**ADDENDUM NO. 4**

**Request for Proposal Call No. RFP2024-418**  
**CONSTRUCTION OF THE FIELD HOCKEY & MULTISPORT TRAINING DOME,**  
**COMFORT STATION AT THE CASSIE CAMPBELL COMMUNITY CENTRE**

CASSIE CAMPBELL  
COMMUNITY CENTRE  
FIELD HOCKEY DOME  
1060 Sandalwood Pkwy W., Brampton ON, L7A 2Z8

ARTIFICIAL TURF  
BASE PAVING PLAN

L-1.1

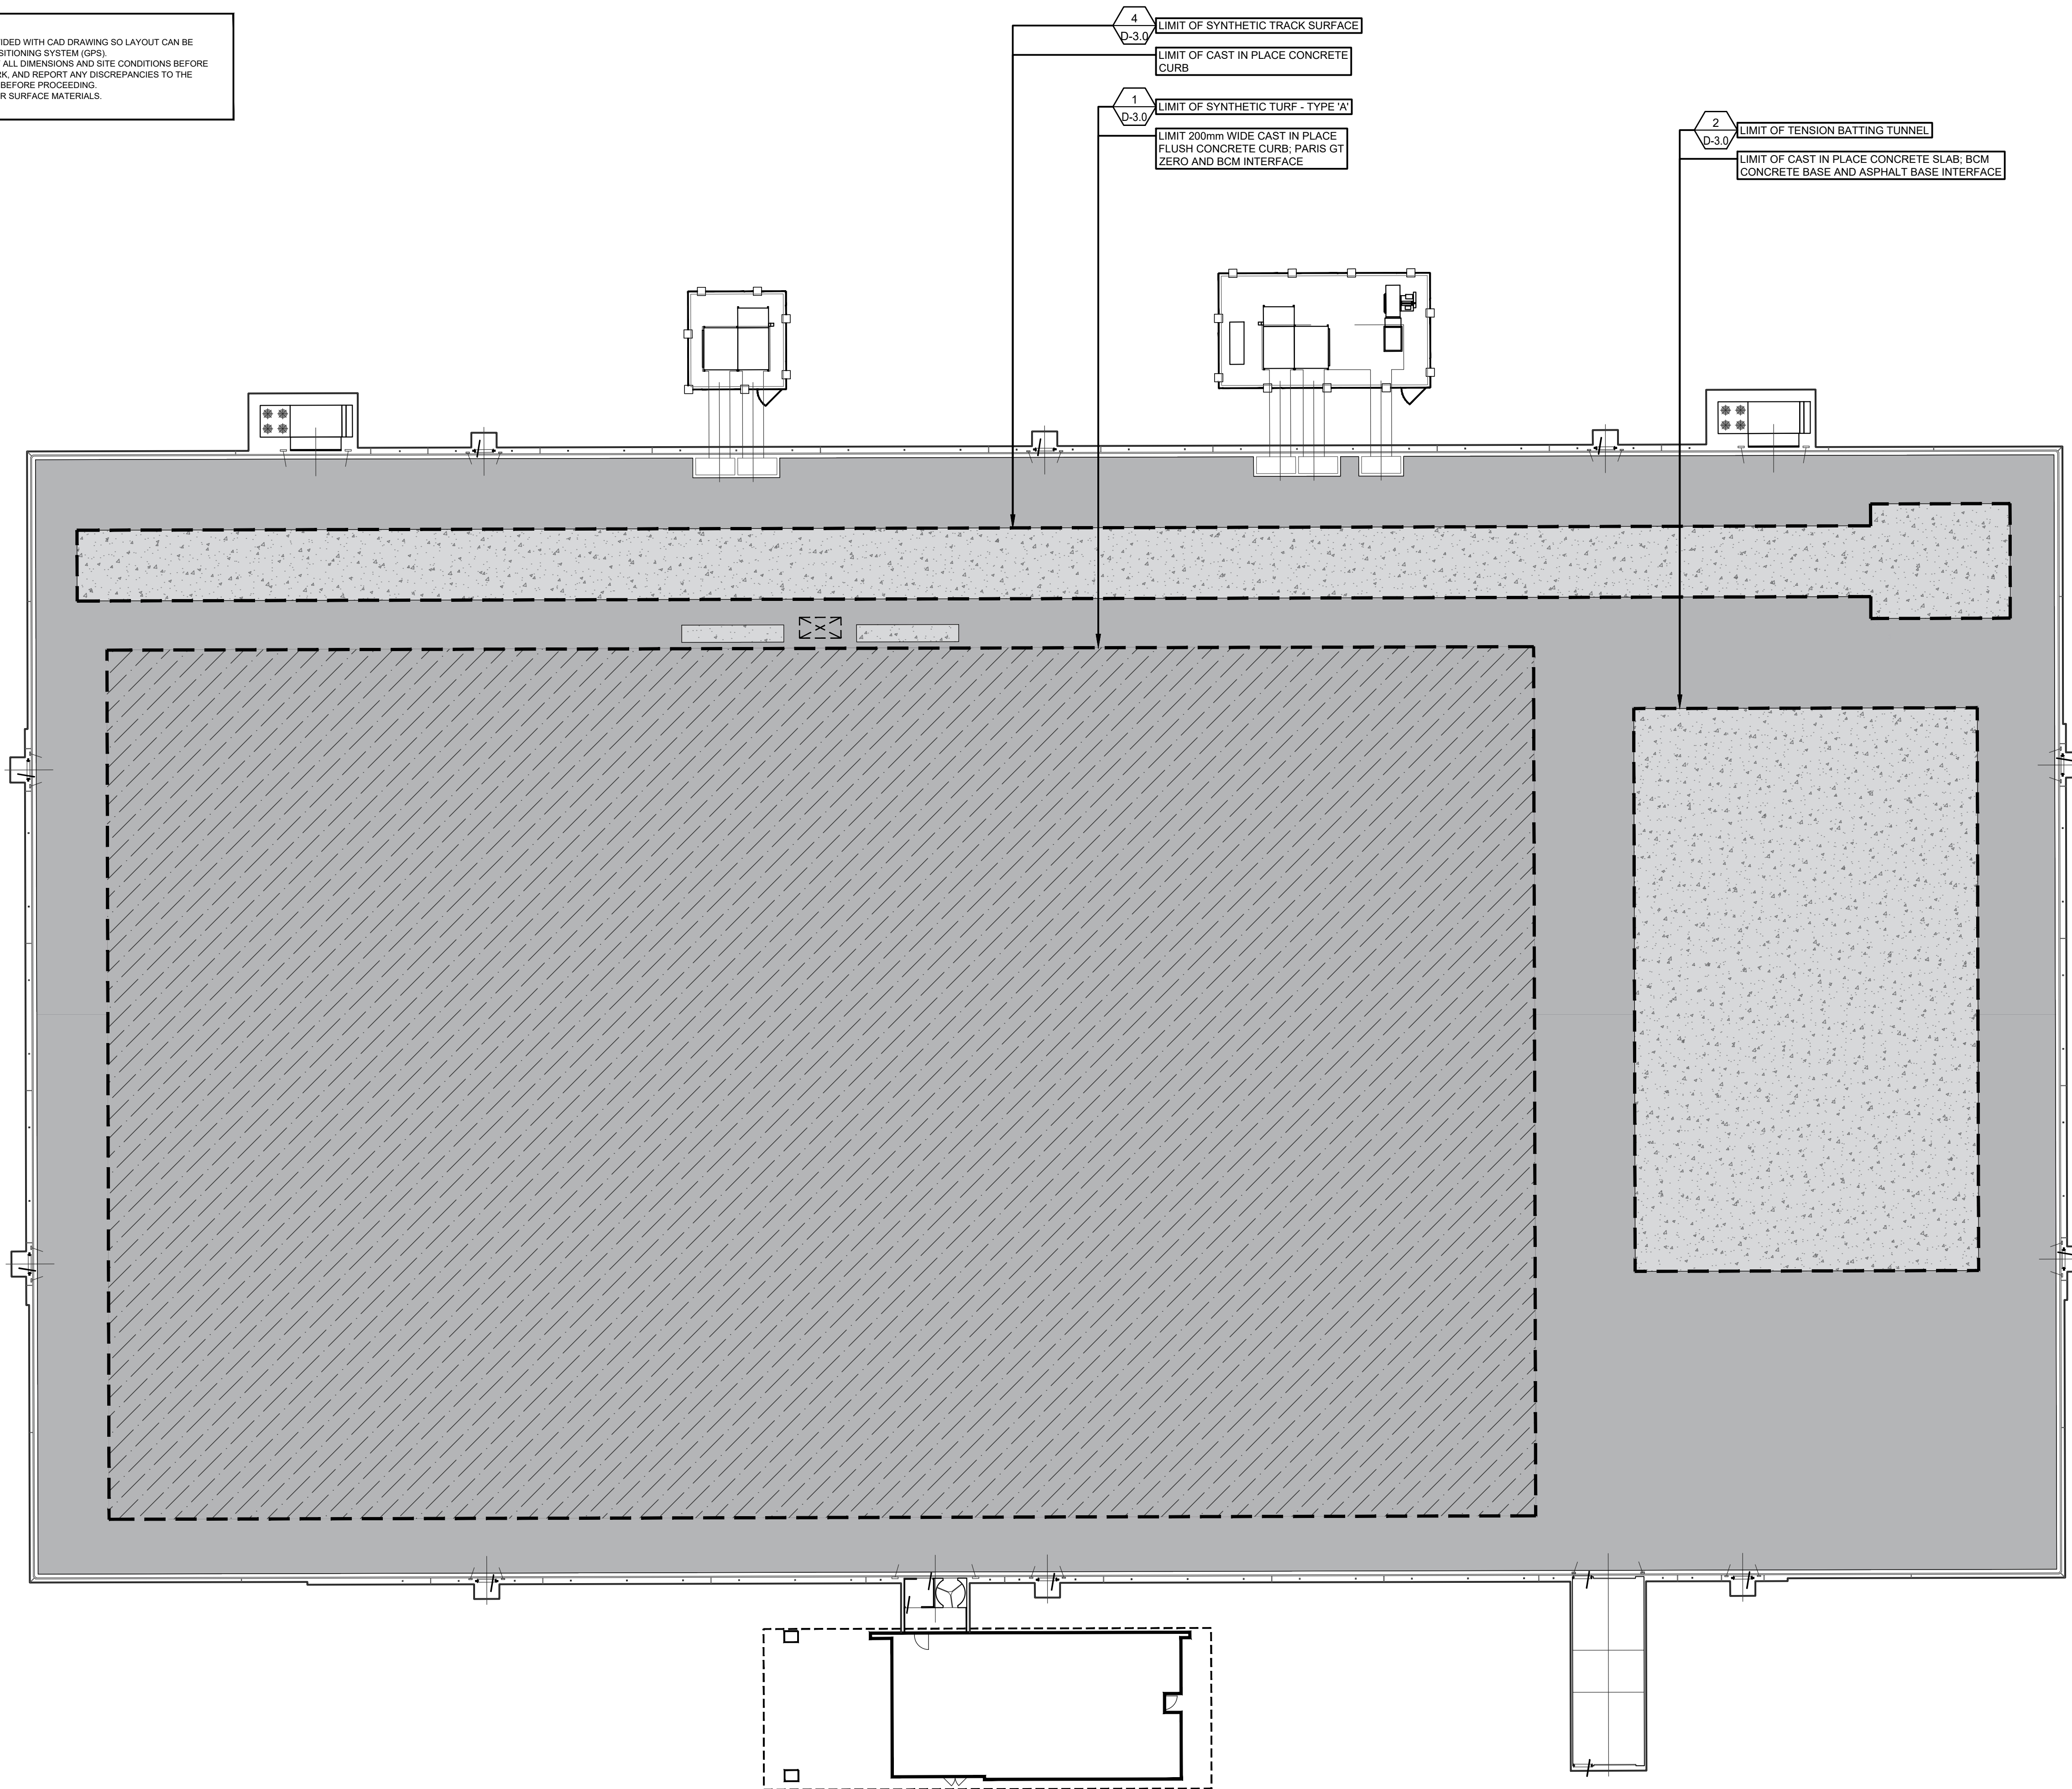
Drawing L-1.1 by Landscape Planning Limited, dated January 16, 2025.

**Q6: The scale on drawing L-1.1 seems to be incorrect. Please provide the drawing with the correct scale so takeoffs can be completed accurately.**

Addendum No. 4 Drawing L-1.1 by Landscape Planning Limited, dated January 31, 2025.

A6: Refer to attached revision of Drawing L-1.1 by Landscape Planning Limited, dated January 31, 2025.
